June 4, 2019
IDEA PUBLIC SCHOOLS – IDEA Palmview Phase I

ADDENDUM NO. 1

A. PURPOSE AND INTENT
This addendum is issued for the purpose of modifying the plans and specifications for the IDEA PUBLIC SCHOOLS – IDEA Palmview Phase I

03 WALL SECTION

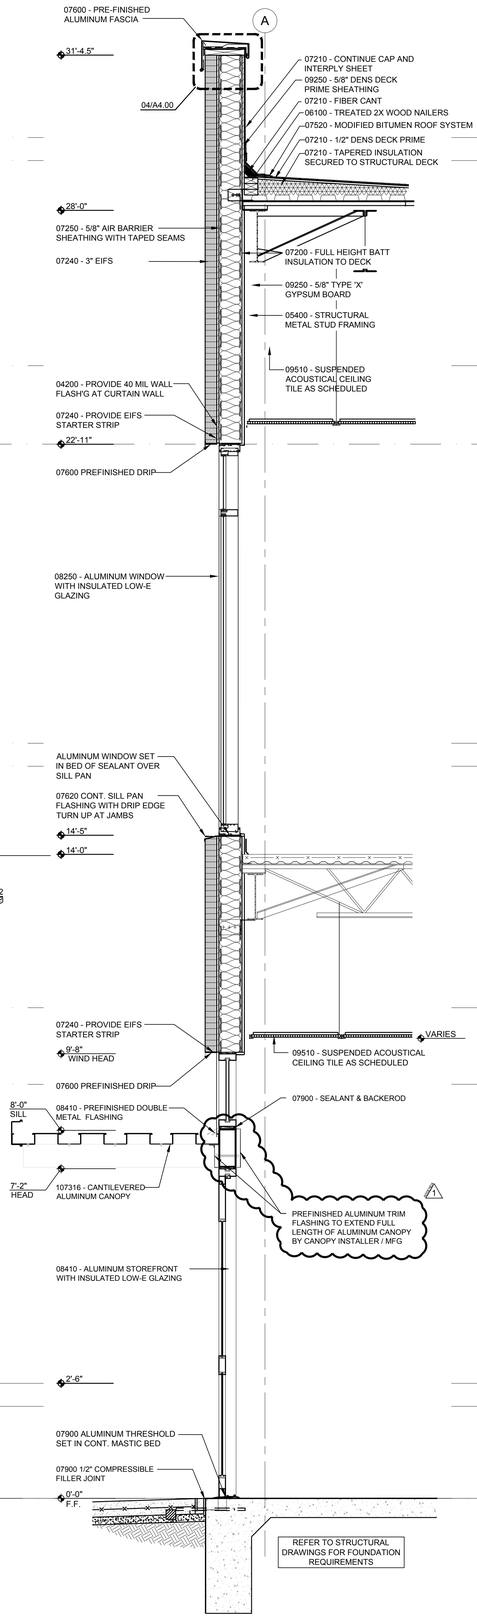
4. Sheet 03/A4.02 – Wall section
   a. Replace sheet A4.02 previously issued with sheet A4.02 included in this addendum.
   b. Include prefinished aluminum trim flashing at exterior and interior to extend full length of aluminum canopy by canopy installer /mfg.

01 PARTIAL BUILDING SECTION

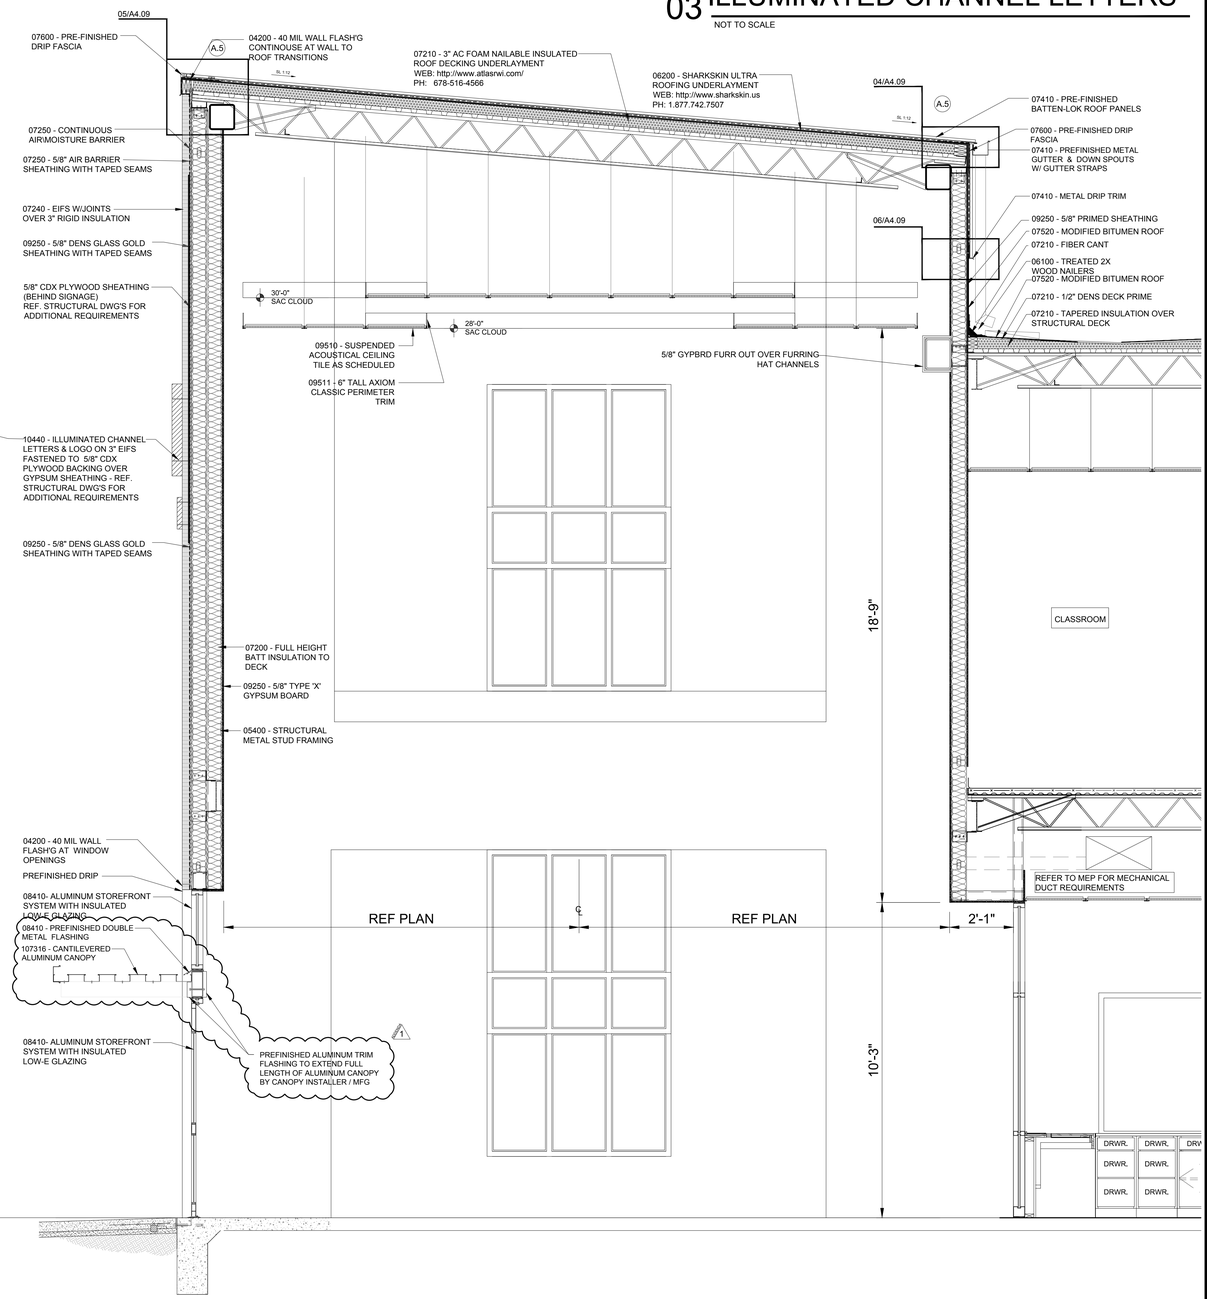
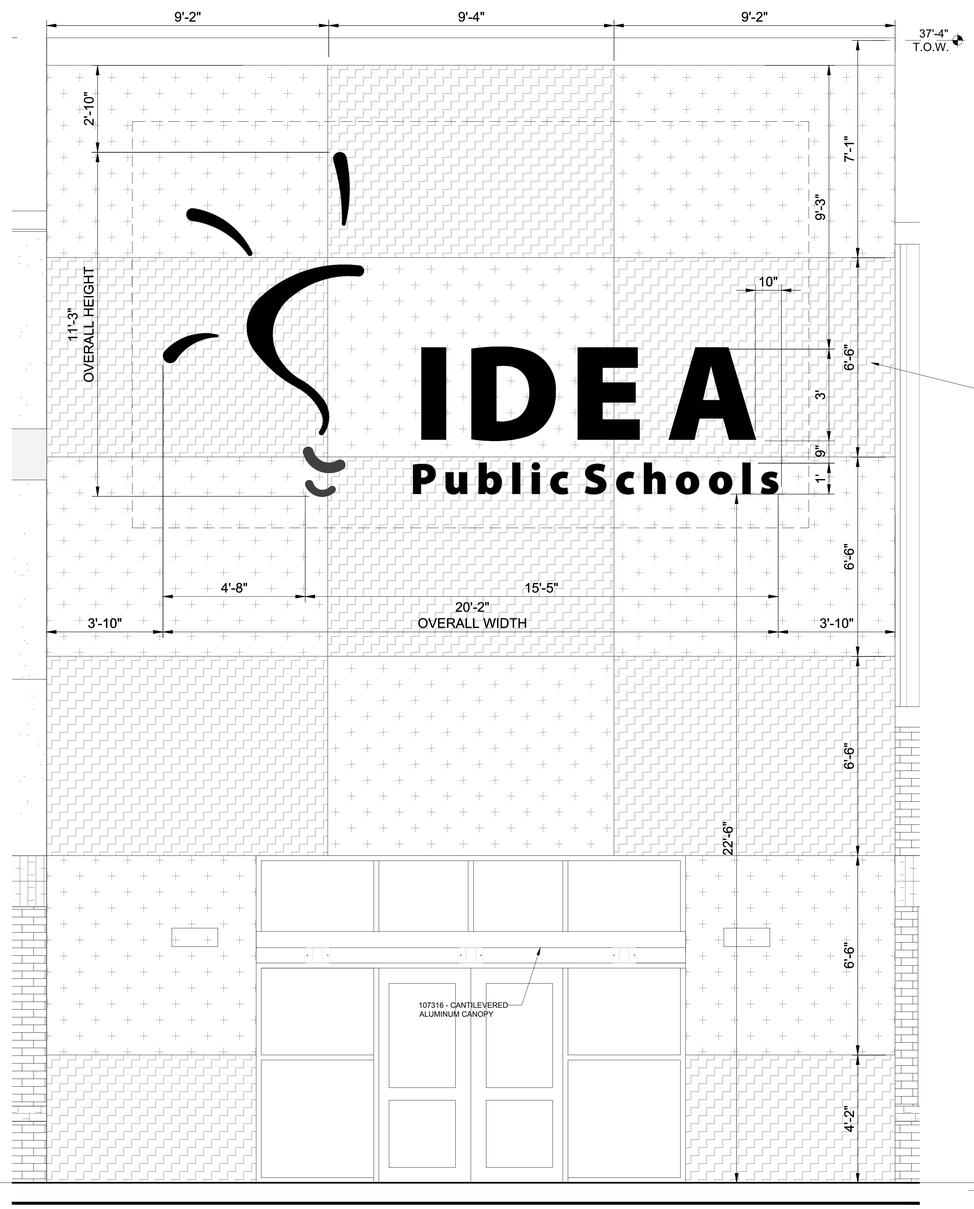
5. Sheet 01/A4.09 – Wall Section

a. Replace sheet A4.09 previously issued with sheet A4.09 included in this addendum.
b. Include prefinished aluminum trim flashing at exterior and interior to extend full length of aluminum canopy by canopy installer /mfg.
c. Include double flashing note
d. Include cantilevered canopy note

Date:	May 16, 2019
Scale:	As Noted
Project Architect:	David Monreal, AIA
Drawn By:	ETHOS
Job No.	IDEA Palmview Phase I
Sheet:	MEP1.01

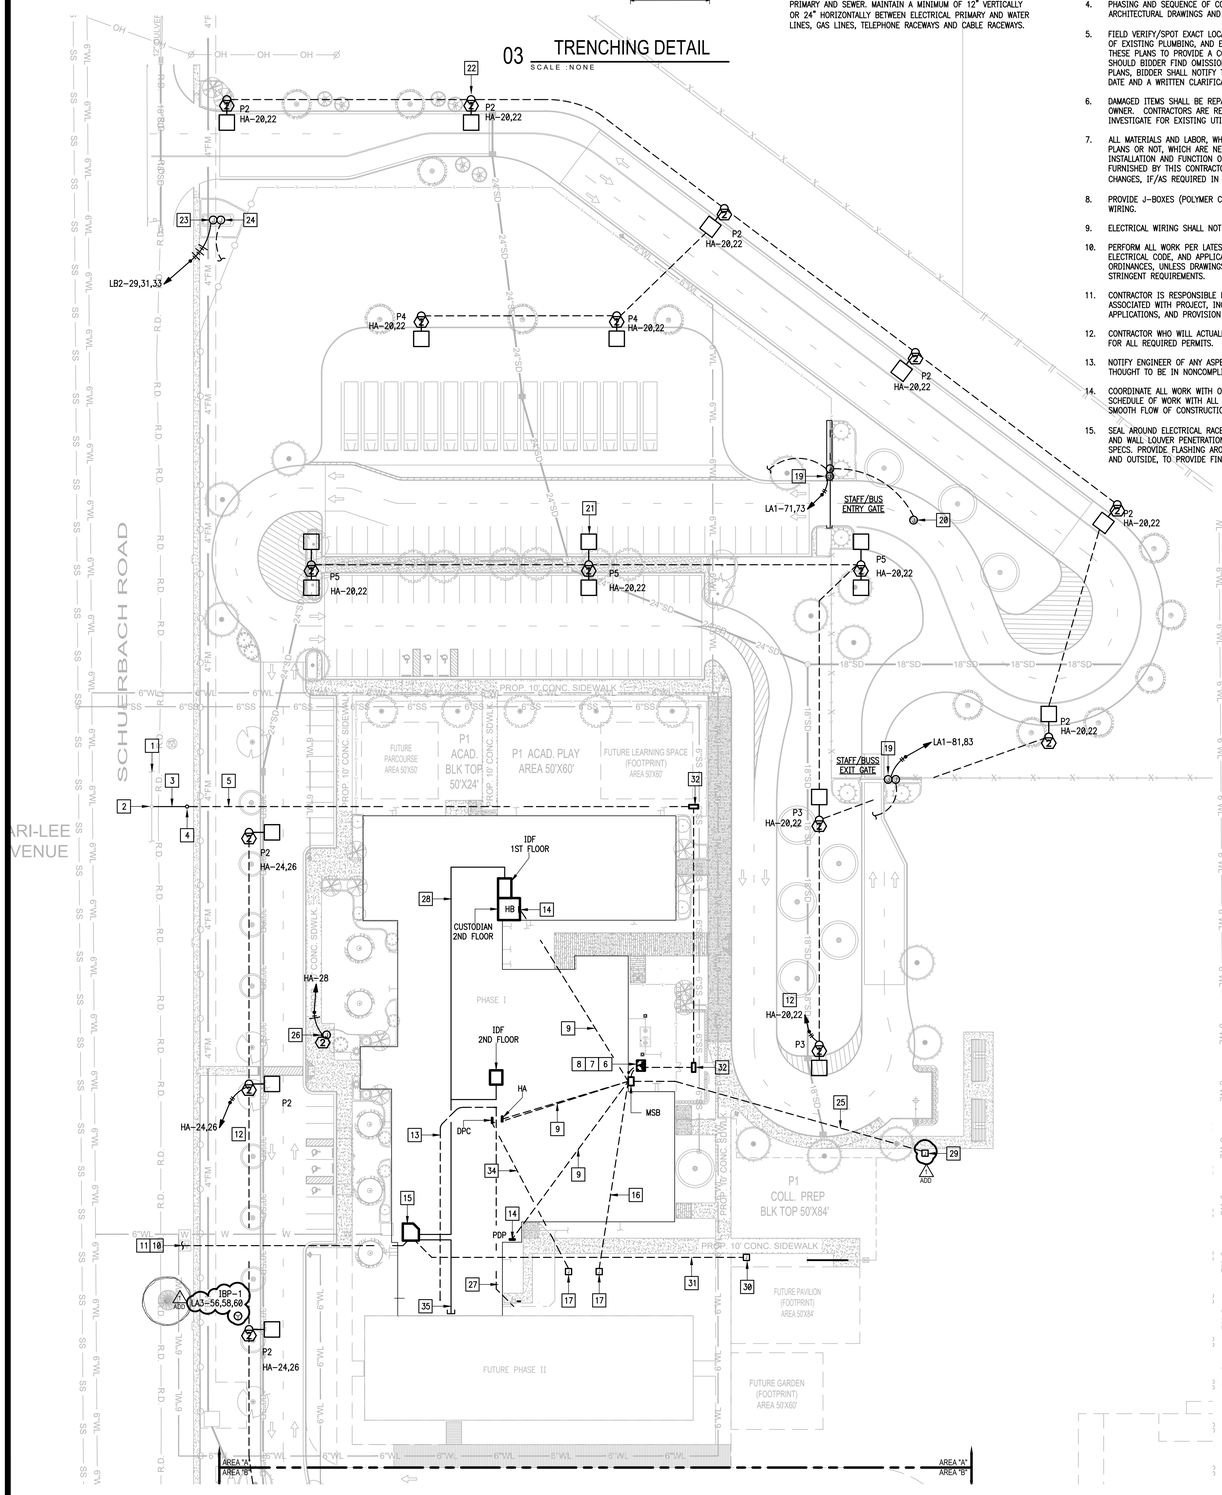
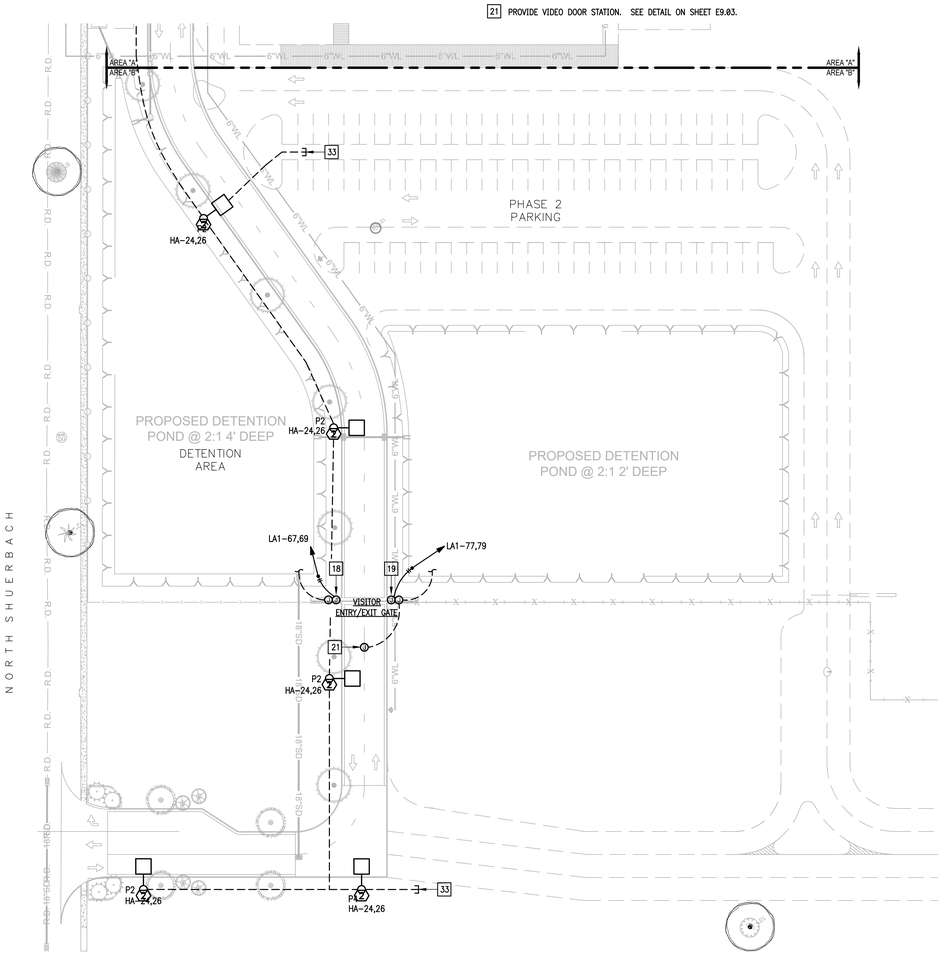
1) Sheet MEP1.01:
    a) Revised MEP Site Plan. See attached sheet.

01 LIGHTING PLAN (1ST FLOOR)

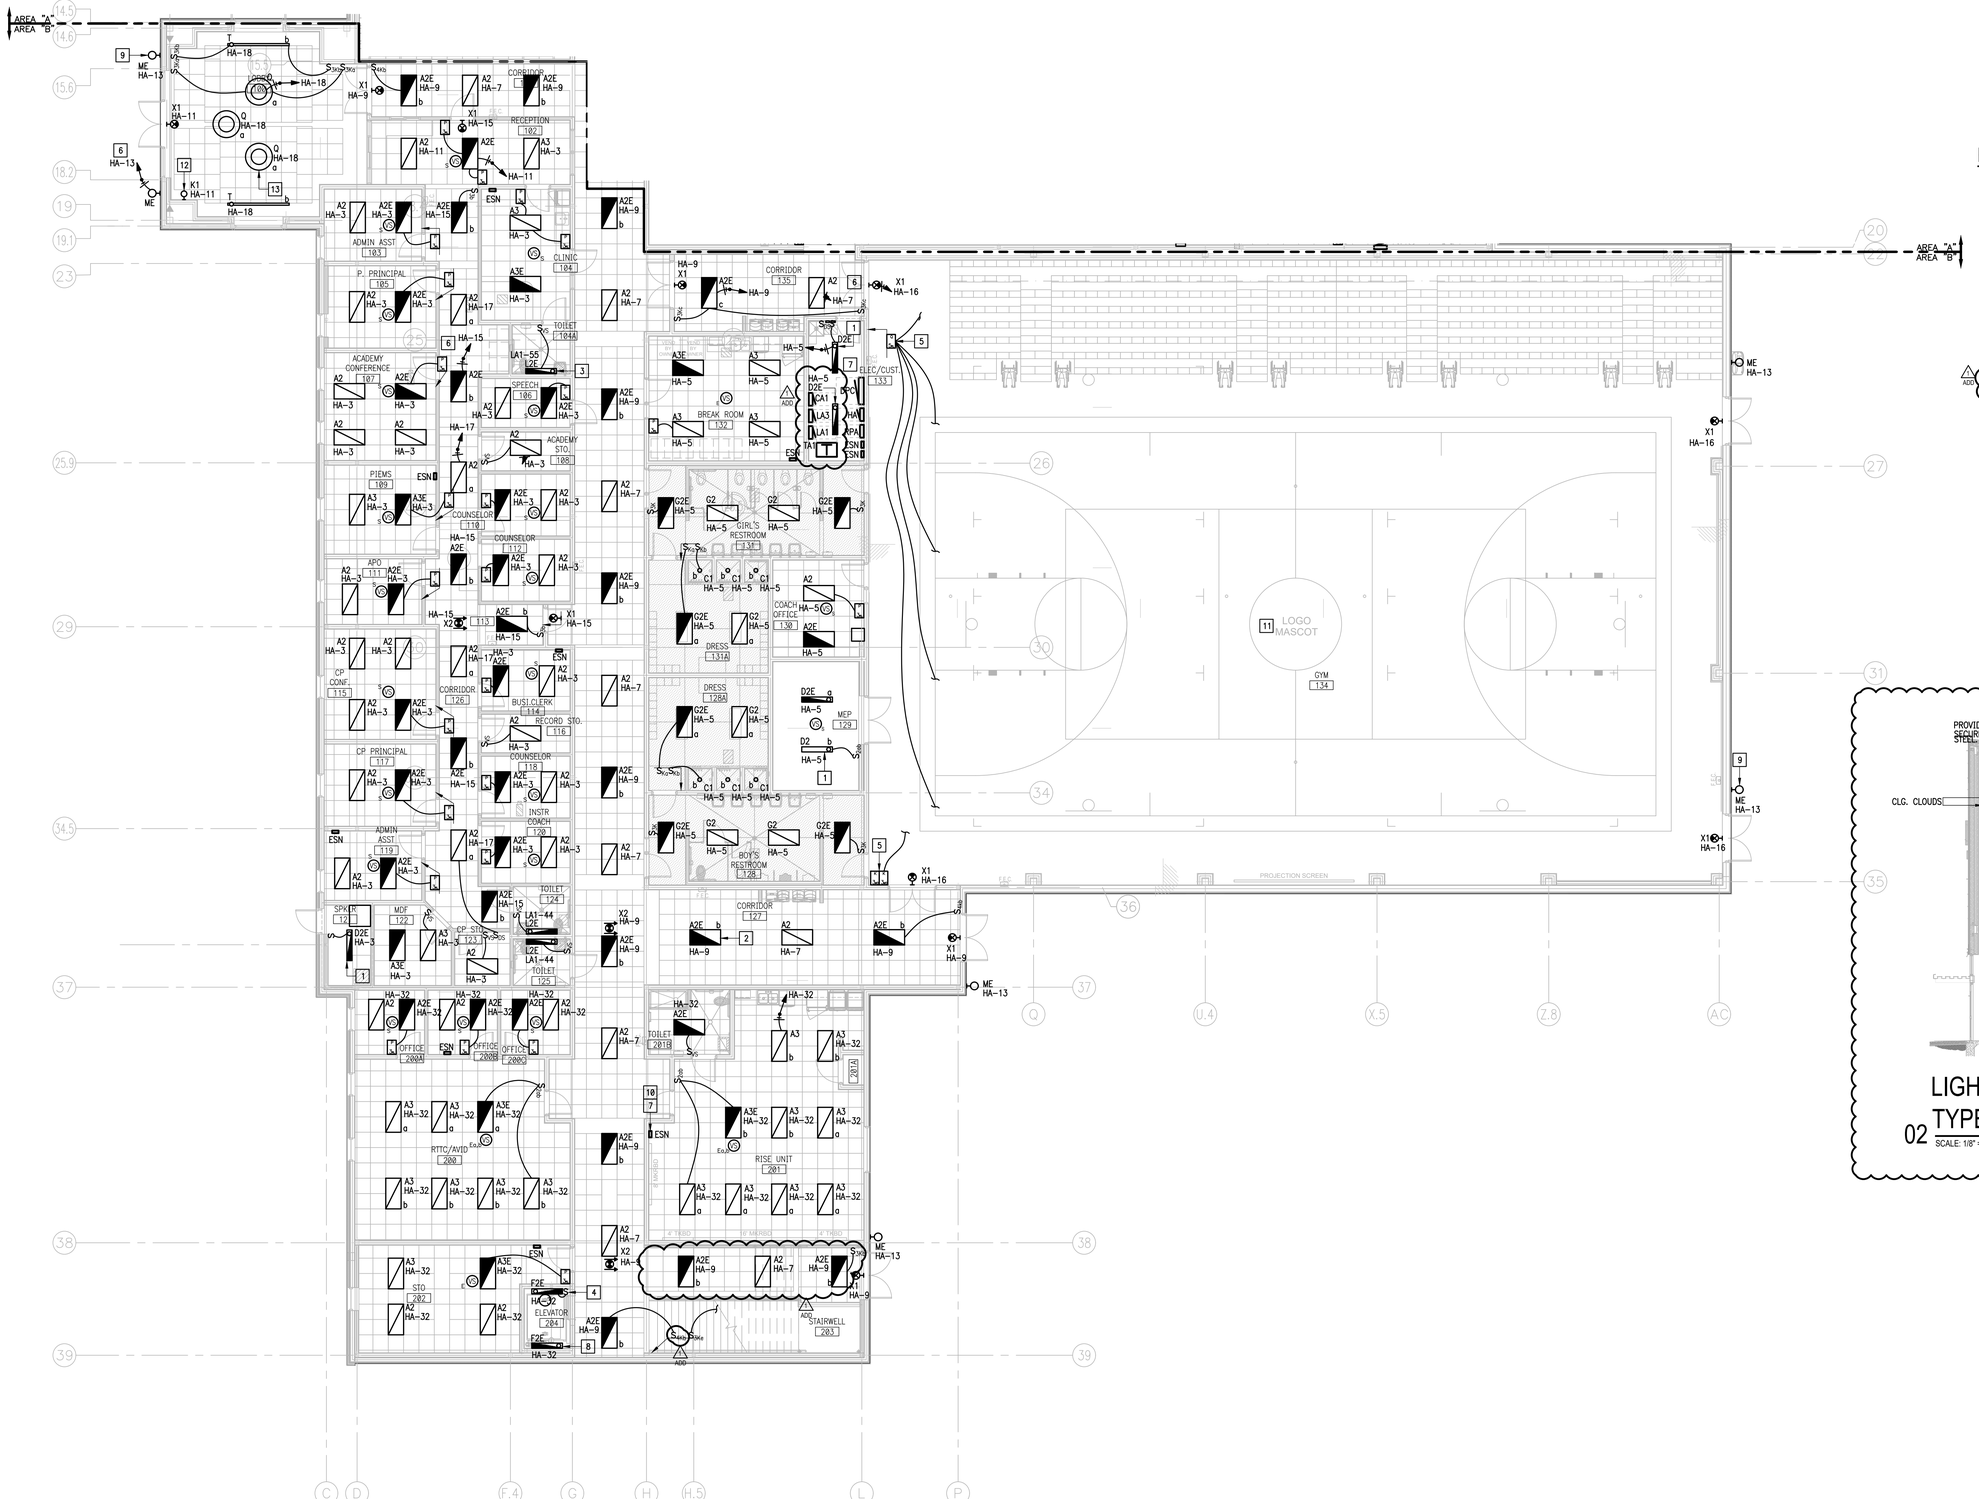
13) Sheet E3.02:
   a) Revised 1st Floor Lighting Plan. See attached sheet.
   b) Keyed Note #6: If Lutron controls are used connect to nearest ESN panel for time schedule control.

Date:	May 16, 2019
Scale:	As Noted
Project Architect:	David Monreal, AIA
Drawn By:	ETHOS
Job No.	IDEA Palmview Phase I
Sheet:	E9.01

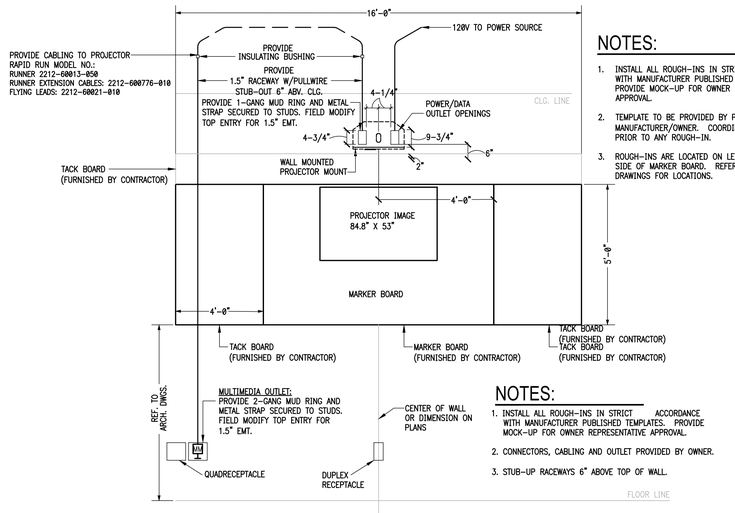
31) Sheet E9.01:
    a) Deleted Electrical Detail. See attached sheet.
    b) Clarification Multi Media Outlet Detail #5: Keyed Note #4 Rapid Run and data cabling to be provided under alternate bid #6.
    c) Clarification Typical Classroom Wall Projector Rough-in Detail #13: Rapid Run cabling to be provided under alternate bid #6.
